Engine Harness Relocation
MP7 US2015
CXU, GU, LEU, MRU

PI0865, Engine Harness Relocation

(December 2015)

W3107068

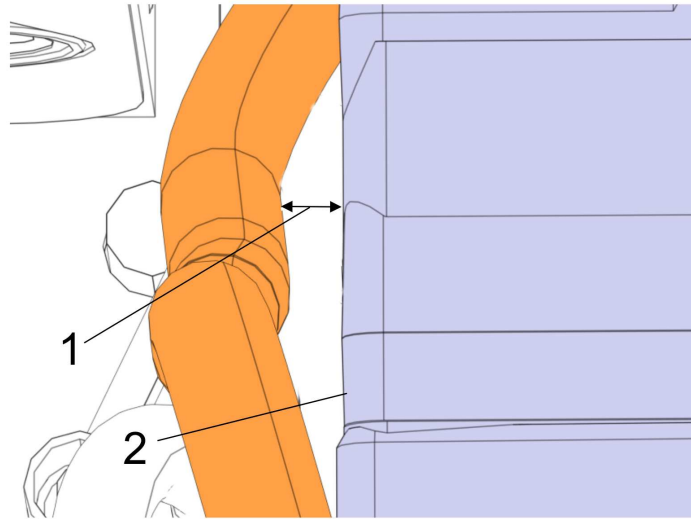
- 9 Relocate the engine harness (2) and install double tie retainers (part number 20885496) as shown (A and B) to secure harness to cylinder head fuel line (3). Ensure harness is not touching air compressor. Make sure the ties are snugged tight.

- 1. Air Compressor
- 2. Engine Harness
- 3. Cylinder Head Fuel Line
